Meadows to George Street - Hanover Street & Market Street

Stage 1 Road Safety Audit

City of Edinburgh Council

September 2022

Problem:	3.2
Location(s):	Hanover Street at George Street
Drawing(s):	60579473-RSA-C-0001
Summary:	Risk of side swipe collisions resulting from carriageway narrowing.

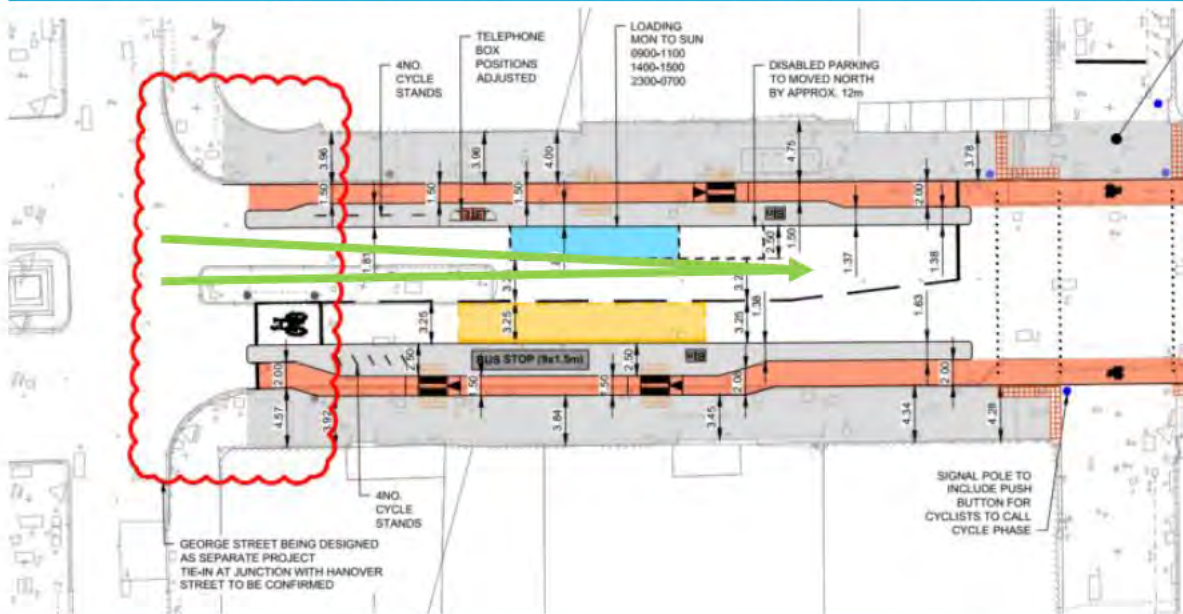
Description:

The southbound carriageway width at Hanover Street, extending from the junction with George Street is 5.75m, before narrowing on the approach to the signalised crossing facilities at the Rose Street junction. It is anticipated that two vehicles may enter Hanover Street side by side, unaware of the lane narrowing, and need to merge ahead. This presents a risk of sudden braking and side swipe collisions.

It is recommended that the southbound carriageway is reduced to one running lane upon entering Hanover Street to remove the need for vehicles to merge.

Problem:	3.3
Location(s):	Hanover Street – northbound approach to George Street
Drawing(s):	60579473-RSA-C-0001
Summary:	Risk of traffic signals being obscured.

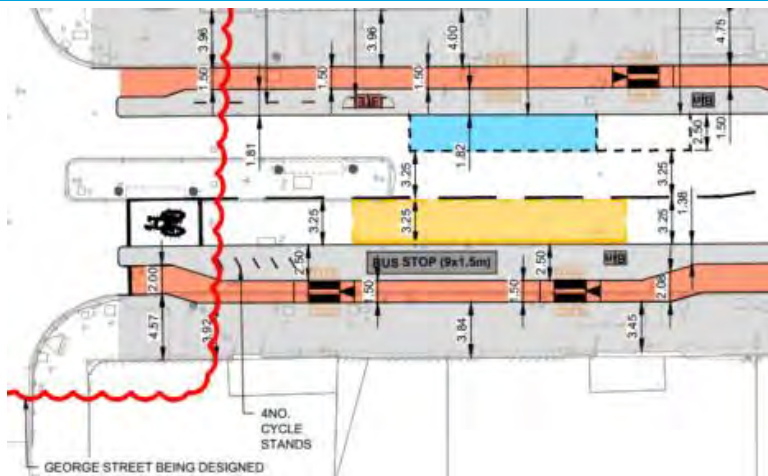
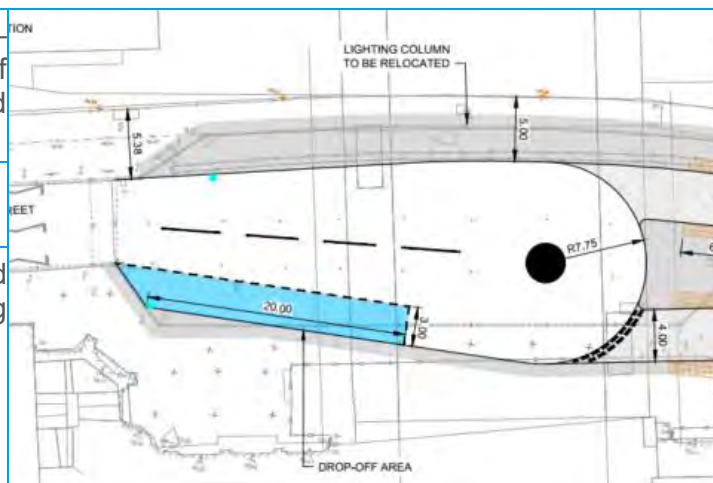
A Response Report was submitted in response to the previous Stage 1 RSA, specifically in relation to the problem raised (Problem 4.2.2) regarding a stationary bus obscuring forward visibility of the traffic signals. Concerns remain regarding the potential for a waiting/loading bus to obstruct forward visibility to the traffic signals and junction ahead.

Insufficient forward visibility may result in vehicles inadvertently overtaking a stationary bus and being unable to proceed and/or re-join their lane due to queuing vehicles or a red traffic signal. This increases the likelihood of vehicles being stranded in the opposing running lane, which may give rise to head on collisions.

It is recommended that the bus stop is relocated and/or sufficient forward visibility is provided for road users.

Problem:	3.5
Location(s):	Jeffery Street at Market Street
Drawing(s):	60579473-RSA-C-0002
Summary:	Risk of pedestrians being struck by passing vehicles.

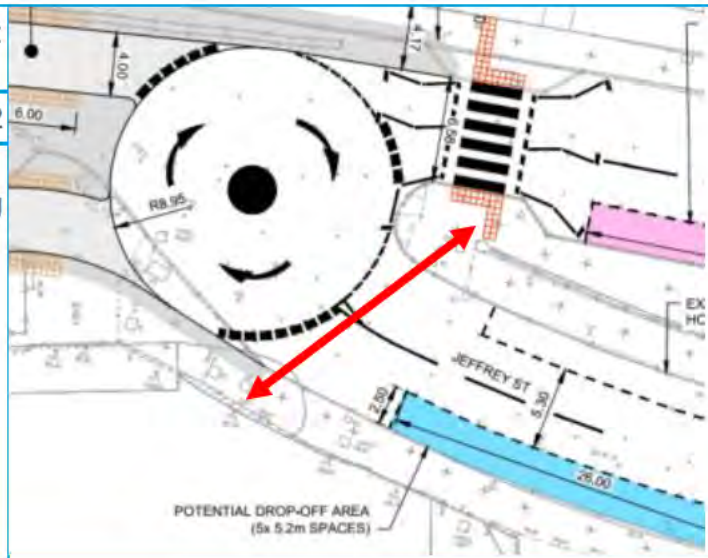
The proposals do not indicate the provision of pedestrian crossing infrastructure at the junction of Jeffery Street at East Market Street. As this presents a direct route to/from the taxi rank and Jeffery Street, it is anticipated that there will be demand to cross this junction, as observed during the site visit.

Due to the geometry of the Jeffery Street and East Market Street junction, pedestrian visibility of oncoming vehicles is restricted. Visibility is impacted further by the railings that extend between the two streets and the on street parking on Jeffery Street. Insufficient visibility of other road users increases the likelihood of pedestrians being struck by vehicles when attempting to cross the carriageway.

There is a secondary risk that without crossing infrastructure in place, pedestrians may trip and fall over full height kerbs at this location.

It is recommended that a controlled pedestrian crossing facility is provided on Jeffery Street.

Problem:	3.7
Location(s):	Jeffery Street
Drawing(s):	60579473-RSA-C-2603
Summary:	Risk of head-on vehicle collisions resulting from large vehicles crossing into the opposing lane to complete turning manoeuvres.

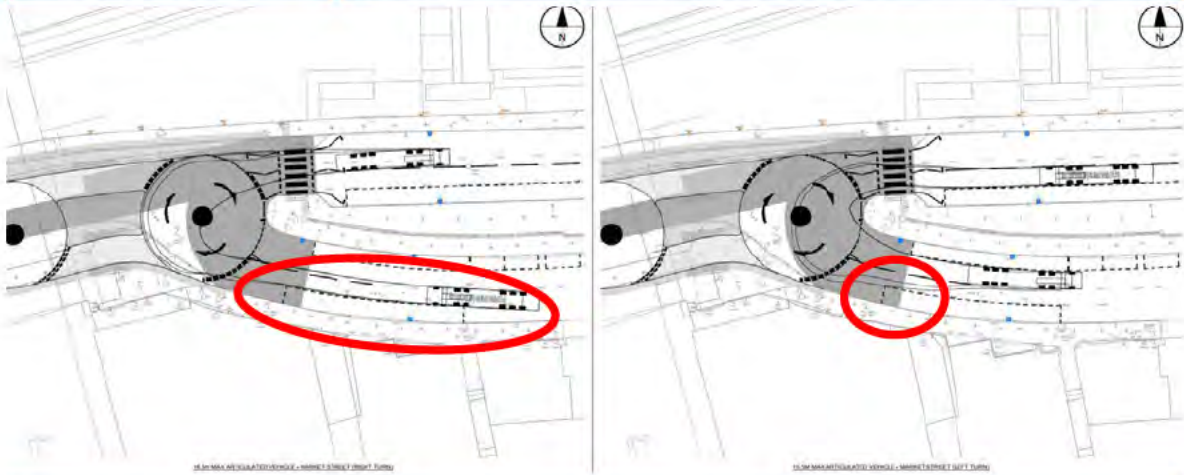
From the vehicle swept path plans provided, the turning manoeuvre of a 16.5m articulated vehicle involves crossing the centreline of both Jeffery Street and East Market Street when negotiating the junction. This increases the risk of head-on collision between vehicles which is exacerbated by the lack of intervisibility between Jeffery Street and East Market Street (see problem 3.7).

In addition, the swept path indicates that vehicles will encroach into the drop-off area proposed on Jeffery Street.

It is acknowledged that the geometry of the road layout is challenging, however, it is recommended that:

- Opposing traffic movements are subject to control to manage access to the junction space; and
- The drop-off area is relocated eastwards so that an articulated vehicle can manoeuvre into and out of Jeffery Street without encroaching into it.

Problem: 3.9

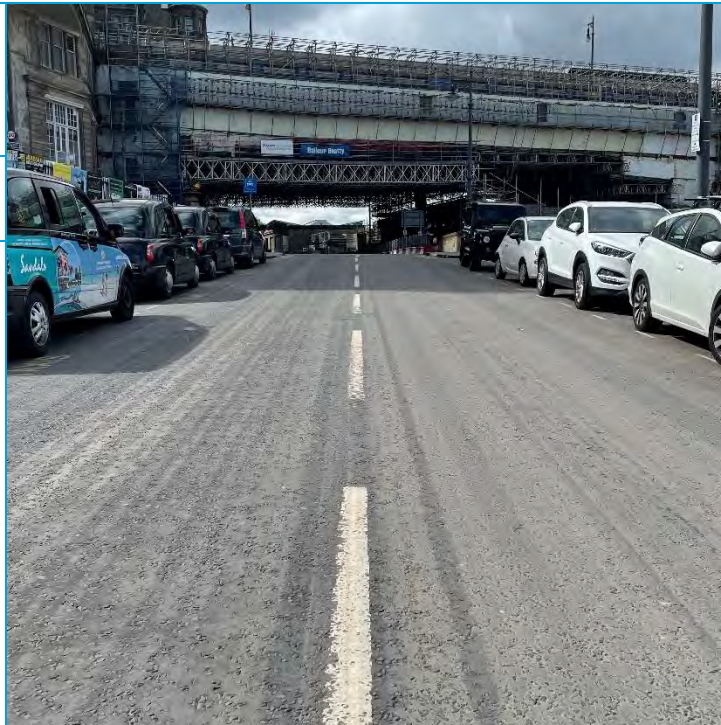
Description:

The East Market Street approach to the proposed mini roundabout is on an incline. Due to this gradient there is a risk that taxis and buses intending to travel ahead onto Market Street, do not have adequate forward visibility of the road layout ahead (see above image).

Drivers may be unaware of the give way or the change in alignment due to the roundabout. This increases the likelihood of vehicles approaching the roundabout at inappropriate speeds and / or failing to give way, subsequently losing control and colliding with other road users and/or the bus and taxi gate infrastructure.

This risk is exacerbated by the see-through effect observed for westbound traffic on East Market Street which is due to the incline, parked vehicles and the perception of a straight road alignment. These factors may also reduce driver visibility of pedestrians approaching/intending to use the proposed zebra crossing facility. This increases the likelihood of pedestrians being struck by vehicles failing to give way.

It is recommended that advanced warning of the roundabout and zebra crossing is provided and that measures are installed to slow vehicles approaching from East Market Street, such as raising the zebra crossing facility (see Problem 3.6).
